AMENDMENT OF SOLICITATION/MODIFICATION OF CONTRACT				1. CONTRACT ID CODE See Block #2		PAGE OF PAGES 1 of 5		
2. AMENDMENT/MODIFICATION NO. N66001-02-R-5017 0004			3. EFFECTIVE DATE 21 Jun 2002		4. REQUISITION/PURCHASE REQ.NO.		5. PROJECT NO. (If applicable)

FOR Questions and Answers (Q&A's) and administrative changes
Regarding SSC-SD RFP N66001-02-R-5017, entitled "Secure Digital Communication Control System."

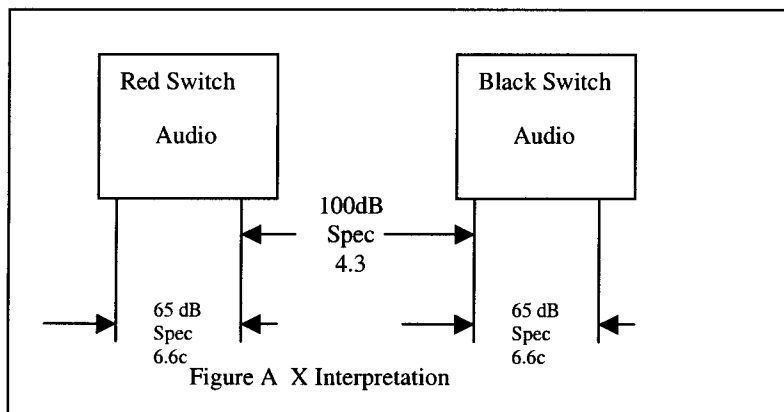
There appears to be a conflict between our interpretation of NSTISSAM/2-95 and the interpretation taken by SPAWAR San Diego. The issue is the Red-to-Red port isolation of 100dB Vs: 65dB.

Government Response: There is no conflict between NSTISSAM/2-95 and the SDCCS Performance Specification. Section 4 of NSTISSAM TEMPEST /2-95 states the requirements for Red Black Electrical Separation. The SDCCS will be a switching device used to interface between Red and Black circuits and equipment. The SDCCS will be located in a non-SCI area. The electrical separation requirements for Red and Black switches are stated in paragraph 4.3b of NSTISSAM TEMPEST /2-95 and is as follows:

Figure A below represents X interpretation of the NSTISSAM/2-95 document. With regard to: Specification 4.3b Red/Black Electrical Separation and Specification ...between Red and Black circuits, and Specification 6.6c ..Multiple Circuit Equipment Crosstalk levels between channels within an equipment

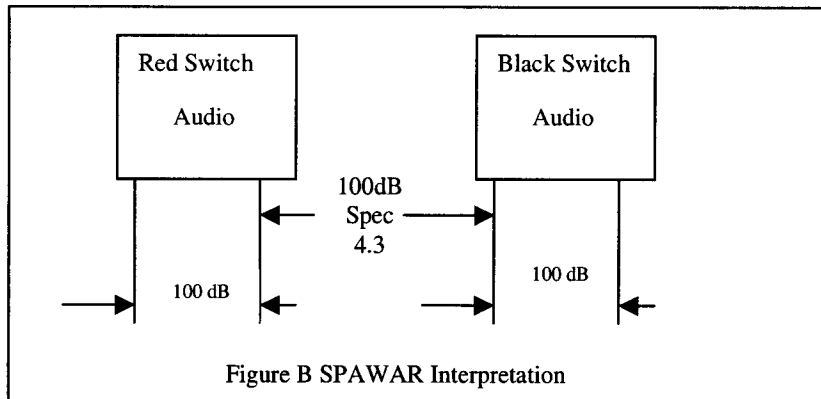
SPAWAR states that the NSTISSAM/2-95 paragraph 6.6c relates only to SCI information. However, the specification states that "...Red unencrypted signal lines may be used to process both SCI and Non-SCI subject to the following conditions...."

The SDCCS specification makes these apparently conflicting statements:

Paragraph	Excerpt
3.2.3.1.16.7	..crosstalk power between any paths in either the red or black section of the SDCCS shall be attenuated greater than 100dB....
3.2.4.6	...classified information shall conform to NSTISSAM TEMPEST 2/95A ...
3.2.4.6.6g	..Red switching devices shall provide at least 100dB between all channels.

If the classified specifications have an impact on the apparent inconsistency we request a visit to view the classified specification.

The Crosstalk and Isolation requirement for the SDCCS is stated in paragraph 3.2.3.16.7 of the Performance Specification. It reads, "Crosstalk power between any paths in either the Red or Black section of the SDCCS shall be attenuated greater than 100 dB below operating

level at all frequencies and under all conditions of network loading. Crosstalk power between the red section and black section of the SDCCS shall be attenuated greater than 100 dB below operation level at all frequencies and under all conditions of network loading....Crosstalk power between any red and black radio, intercom and telephone paths at the operating stations shall be attenuated greater than 100 dB below normal operating level at all frequencies and under all conditions of channel selection.”

The above requirements, from the Performance Specification, are in direct agreement with the requirements for RED/BLACK electrical separation as stated in NSTISSAM TEMPEST/2-95 paragraph 4.3b.

The 65 dB requirement is for RED SCI and RED Non-SCI electrical separation within a Sensitive Compartmented Information facility. The first sentence in the General section of Section 6 reads, “This appendix sets forth criteria to permit RED sensitive compartmented information (SCI) and RED non-SCI to be processed through components of a single RED distribution system.” The SDCCS application is not for SCI. The SDCCS, as specified in the performance specification, is a RED/BLACK GENSER distribution system. The SDCCS performance specification does not reference any requirement for the distribution of RED SCI data. It references the distribution of RED/BLACK data, therefore Appendix 6 and its subparagraphs do not apply to the SDCCS.
